RE: Variance- Beatley Property
608 Overhill Dr. Edgewater, Md. 21037
Tax Account# 1411-9003-5617
Zoning R-2 CA Designation: LDA BMA : Yes

OFFICE OF PLANNING AND ZONING
CONFIRMATION OF PRE-FILE

PRE-FILE #: 2024-0010-P
DATE: 02/02/2023
OPZ STAFF: Jennifer Lechner
Kelly Krinetz

LOCATION DRAWING OF:

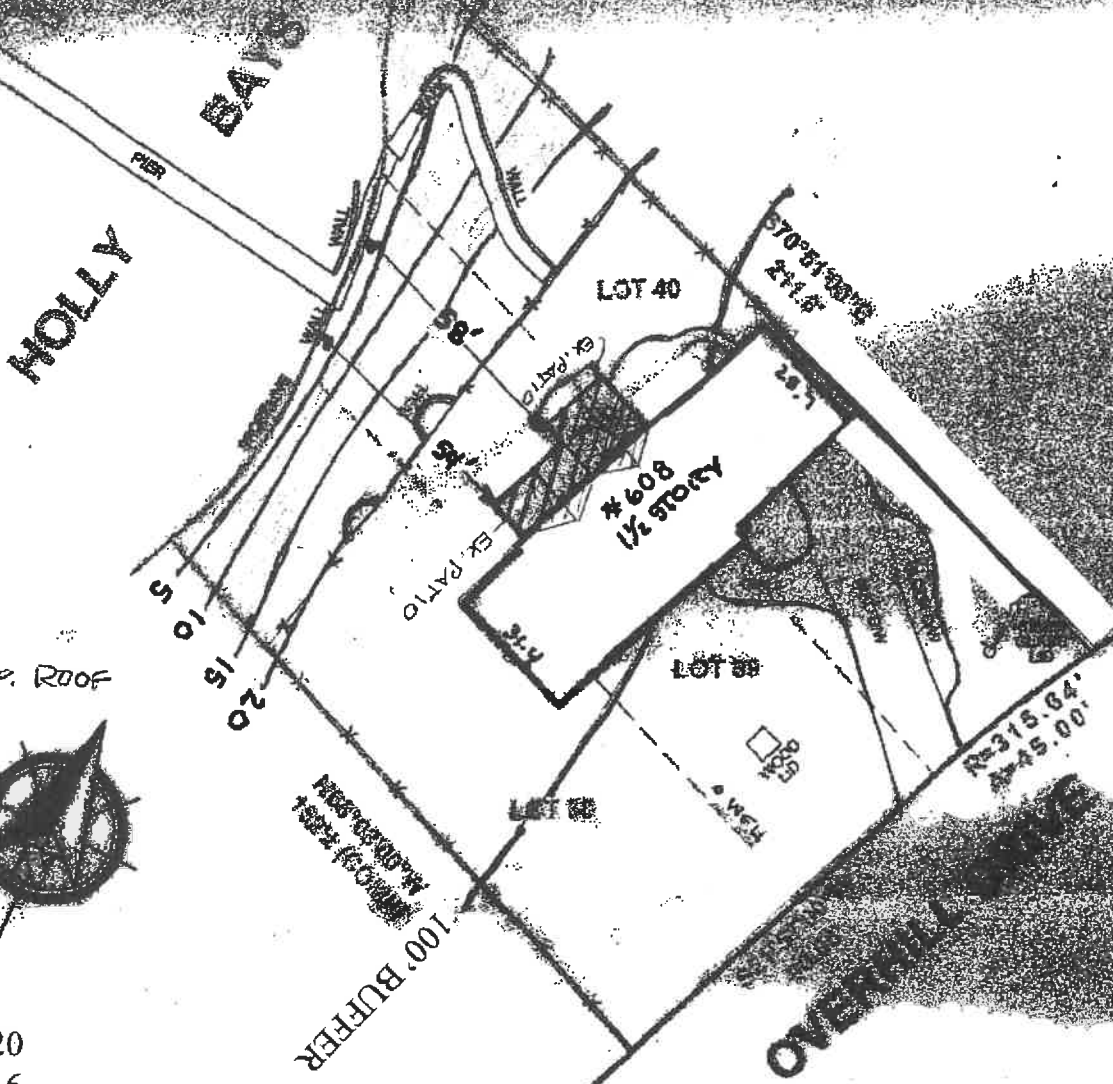
No objection provided the development is limited to a roof structure only with no enclosure and does not expand beyond the existing patio area.

The disturbance will fall within the required steep slope buffer and a modification will be required.

The Administrative Site Plan should clearly indicate the dimensions (including the height) and setbacks for the proposed development. Please be sure that the setbacks are measured perpendicular to the shoreline, rather than perpendicular to the structure. The site plan indicates 60' to the shoreline wall, but the shortest distance measures closer to 51' for the 10 x 20 roof and 53' for the 15 x 16 roof.
